Wilson Walk
208/210, 220, 230,
240 Wilson Street

CURRENT ISSUE
May 14, 2019

List of Plan changes		
Revision	Page	
1	A01	added keypad for guest entry to access 1 guest parking stall below
2	A01	area of parkade that will be above existing grade is now noted in grey. Parkade will be entirely below finished grade
3	A01	unit numbers changed to account for bachelor units being sold as separate strata unit. This has been shown to be more favourable to council
4	A01	See civil drawings for change in driveway as well as detail 3 on A18. drive aisle held to 8% in order to confirm to parking bylaw.
5	A01	Project site data table updated: 1)added site coverage including parkade above original grade, 2)bachelor suites have been separated out to have their own unit number as they are proposed as separate strata units now. The are below 1.8m so the square footage is not calculated in the FSR.
6	A07	All perspectives have been updated with more realistic and suitable trees and plantings. Please see civil for all road and sidewalk details/ curb cuts, etc.

A18
2 record of plan changes from march 14, 2019

A08 Parkade Plan
1 scale: 1/8" = 1'-0"

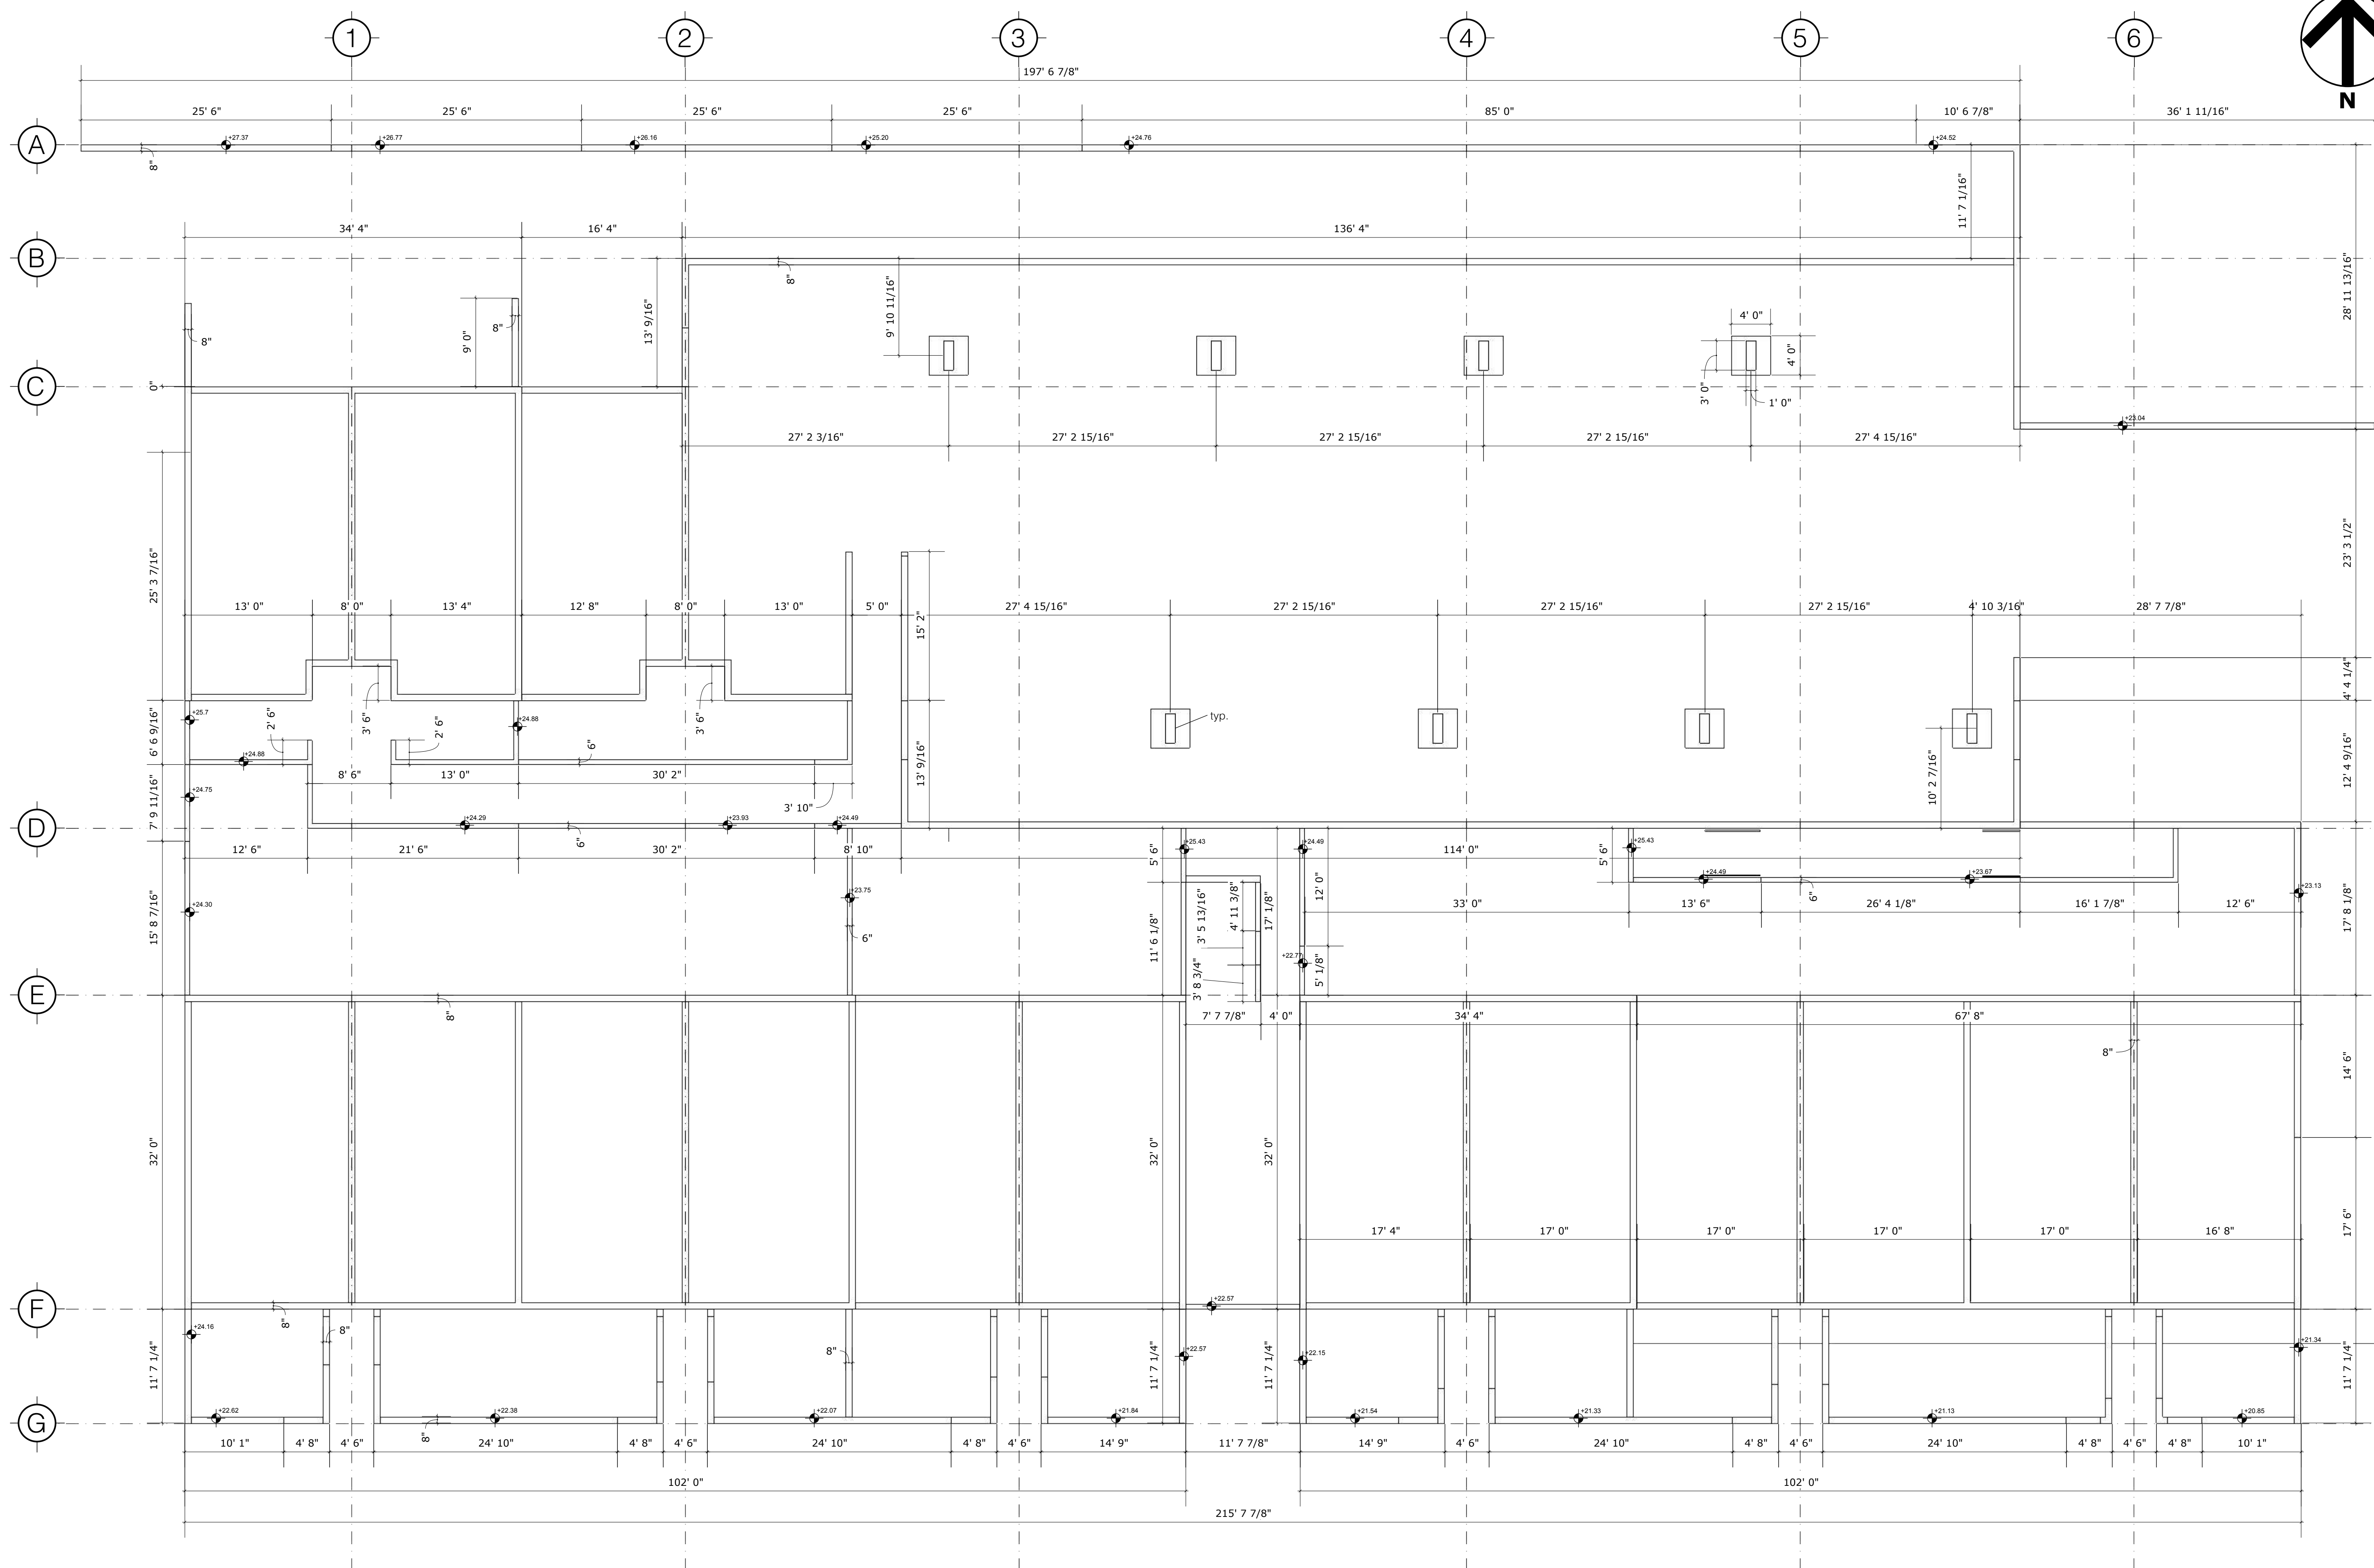
7	A08	door was removed and locking gate was introduced to increased ventilation as per consult with mechanical engineering. Total travel distances were re-calculated and are conforming to BCBC2018
8	A08	Gridlines were added to all floor plan layouts typ. to add clarity.
9	A08	example of Wilson Walk Project signage on East side of north building to add further clarity to that building face given questions brought up during ADP review.
10	A10	units 29-34 main floor elevation was raised to allow for better clearance/access into parkade. Jim requested that we allow for any possible increase that could be required given structrual engineering requirements at this stage rather than later so we have.
11	A11	units 29-34 upper floor elevation was raised to allow for better clearance/access into parkade. Jim requested that we allow for any possible increase that could be required given structrual engineering requirements at this stage rather than later so we have

A12 Roof Plan- see legend below
1 scale: 1/8" = 1'-0"

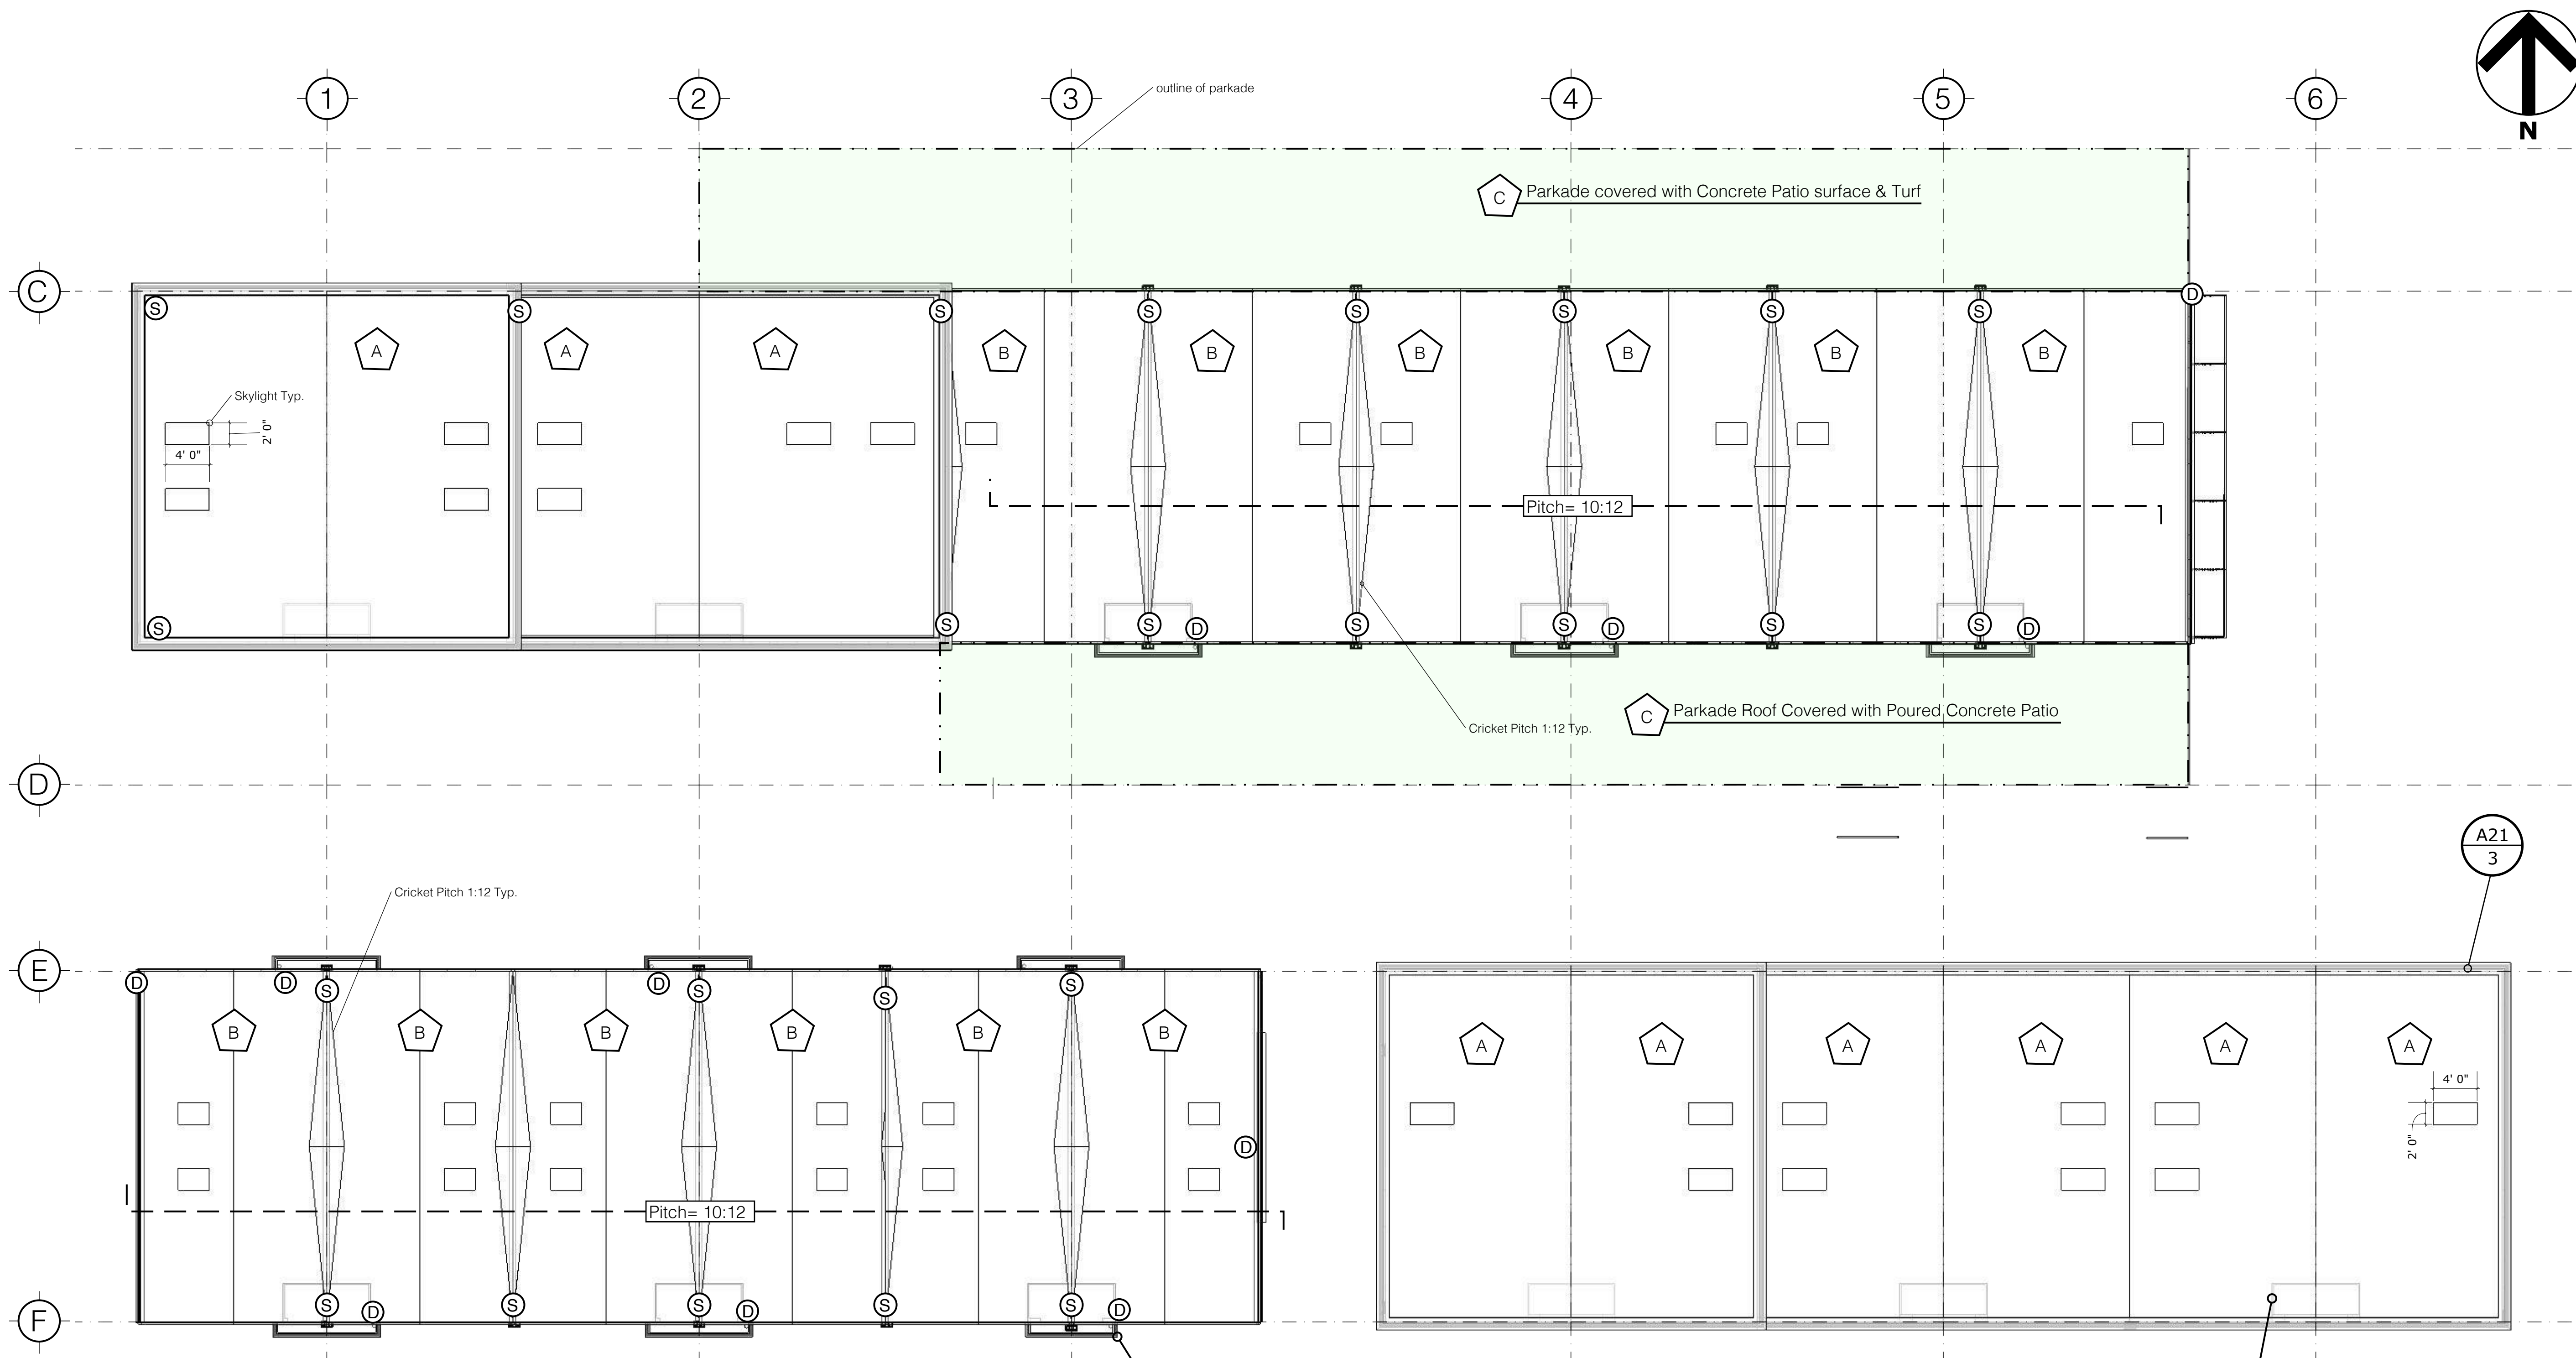
12	A12	roof pitch was changed from 12:12 to 10:12 to keep height of building consistent from what was shown previously given the requirement to raise both the main and upper floors to create better parkade headroom clearance at entry door.
13	A17	changes to height calculations and floor elevations as per above revisions 10 & 11
14	A18	Detail 3 was updated to show how we are complying with drive aisle slope % max as per parking bylaw.
15	A20	dimensions were added in parkade cross sections to better show that we are meeting our 2.1m height clearance requirement. The engineers and architect are well aware of the head clearance requirements and we are and conforming.
16	A22	added detail for front entry stairs from south building leading to sidewalk on Wilson as per feedback from ADP review. Spindle change, dimensions, profiled top cap, return at bottom of stairs and eased transitions.
